# Access Compliance Report

## Public Rights-of-Way

### (Curb Ramps)

Intersection ID: 23951	Main Street: S_TRYON_ST	Cross Street: CHOATE_CR	Location: SE
ADA ID: 1B802B6B3D09	Ramp Type: Perp	Initial Pass/Fail: Pass	Overall Compliance: No
Severity Score: 22.5			
Codes/Mitigation Info/Possible Solution		Field Measurements/Component Compliance

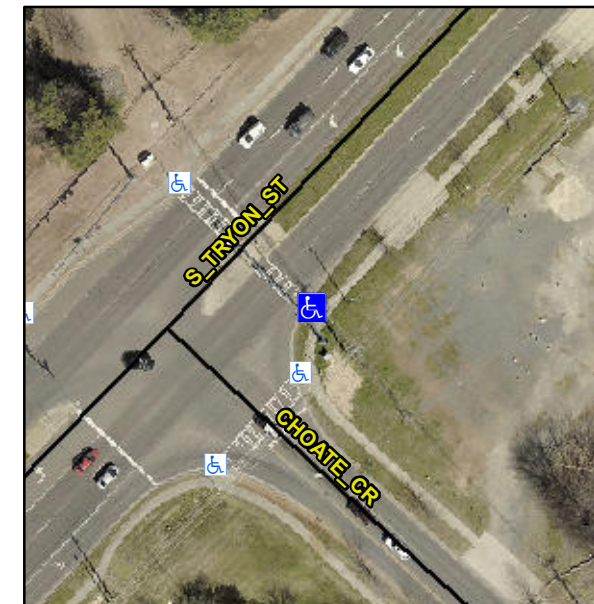
**Install Landing. Remove & Replace Gutter.**

**R304.2.1, R304.2.2-Perp, R304.3.2-Para, R304.5.3, R302.7, R302.7.2, R304.5.4**
